SUNDRY NOTICES AND REPORTS ON WELLS
(DO NOT USE THIS FORM FOR PROPOSALS TO DRILL OR TO DEEPEN OR PLUG BACK TO A DIFFERENT RESERVOIR. USE "APPLICATION FOR PERMIT" (FORM C-101) FOR SUCH PROPOSALS.)

Attachment C-103
OXY USA Inc
Cedar Canyon 15 SWD #1
API No. 30-015-42797

OXY respectfully requests to change the injection tubing string as follows:

OXY USA Inc.
CedarCanyon 15 SWD #1
API No. 30-015-42797

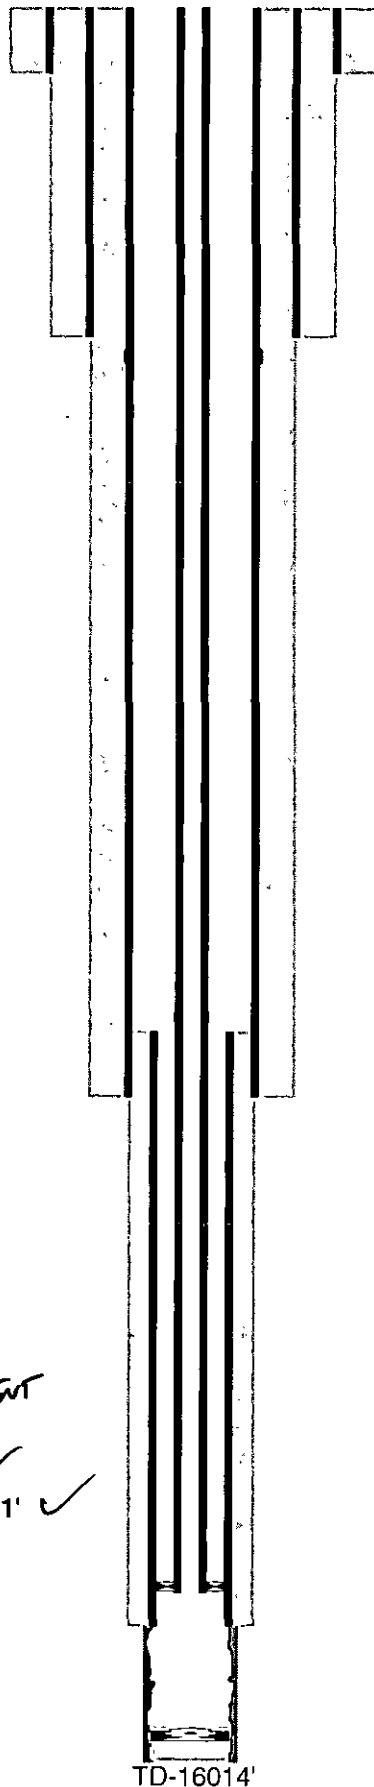
- a. Stop injection operations
- b. Pull existing 4-1/2" 11.6# L-80 tubing out of the hole
- c. Run new tubing string of 5-1/2" 20# L-80 BTC to 9655' (100' above top of 7" liner) X/O to 4-1/2" 15.1# L-80 BTC to 14,781'. Both tubing strings will be lined internally with Duoline anti-corrosion lining
- d. OXY will notify NMOCD 24hrs prior to running MIT

5-1/2" 20# L80 Duo-Line tbg @ 0-9655' ✓

4-1/2" 15.1# L80 Duo-Line tbg @ 9655-14781' ✓

AS pkr @ 14781'
